# RENESAS TECHNICAL UPDATE

| Product Category   | MPU&MCU                                  | Document No. | TN-SH7-A724A/E       | Rev.  | 1.00 |
| Title              | Note on Use of SH7763 SIOF Master Mode 2 |              | Information Category | Technical Notification                            |      |
| Applicable Product | SH7763 Group                             | Lot No.      | Reference Document   | SH7763 Hardware Manual Rev.2.00 (REJ09B0256-0200) |      |

Figure 1. SIOF\_SYNC Output Timing in Master Mode 2 (Transfer Started)

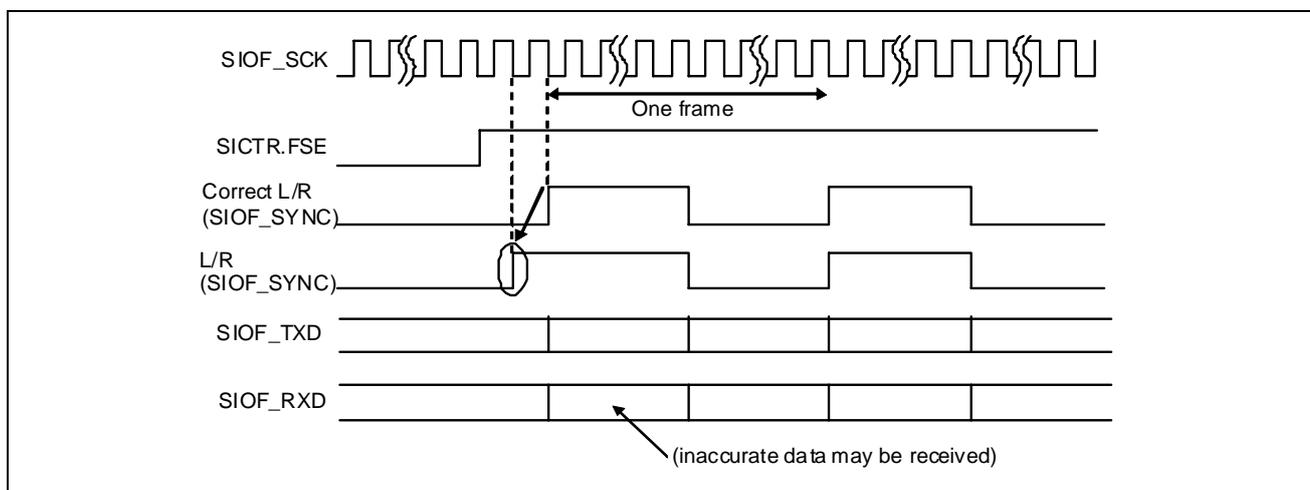
When using master mode 2 of the SIOF, if a transfer is started as set SICTR.FSE to 1 after reset, the first L/R signal (SIOF\_SYNC) is always asserted early for one clock (see figure 1). And if a transfer is suspended as clear SICTR.FSE to 0 and resumes as set SICTR.FSE to 1 again, the first L/R signal may be asserted one clock late (see figure 2). In any case, an inaccurate data may be received at the first slot of received frame.

1. When the L/R signal asserted early for one clock.

There is no suitable workaround about the SIOF of the SH7763. If this operation is the problem in your system, take the countermeasure on your system for example ignore the first data.

If any countermeasure cannot be used on your system, use the SSI instead of the SIOF.

Figure 2. SIOF\_SYNC Output Timing in Master Mode 2 (Transfer Resumed)

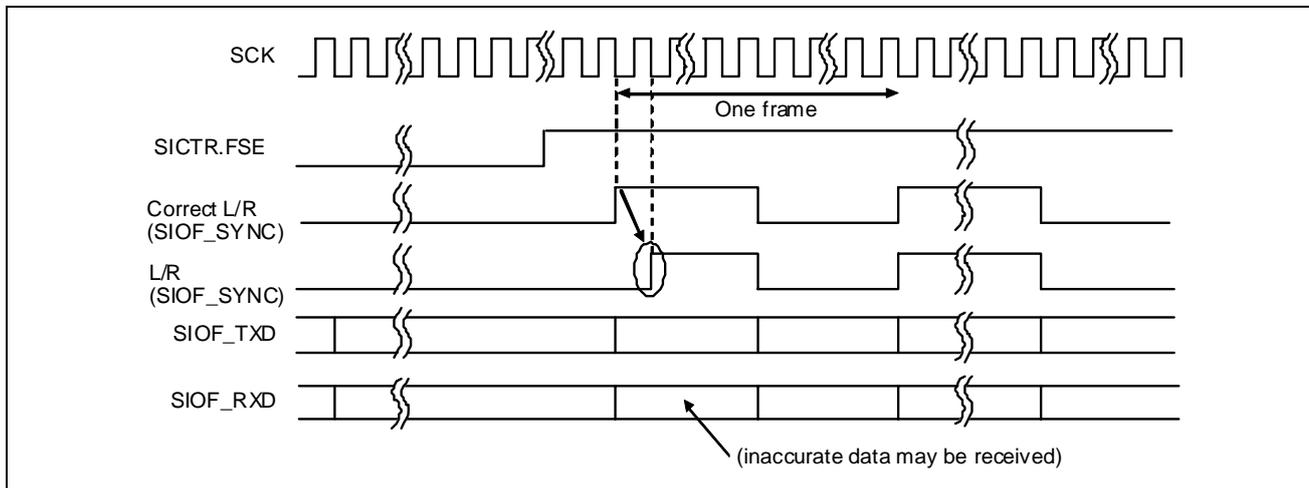
2. When the L/R signal asserted one clock late.

Never suspend as clear SICTR.FSE to 0 during the transfer. When suspending the transfer, clear the TXE or RXE bit in SICTR.
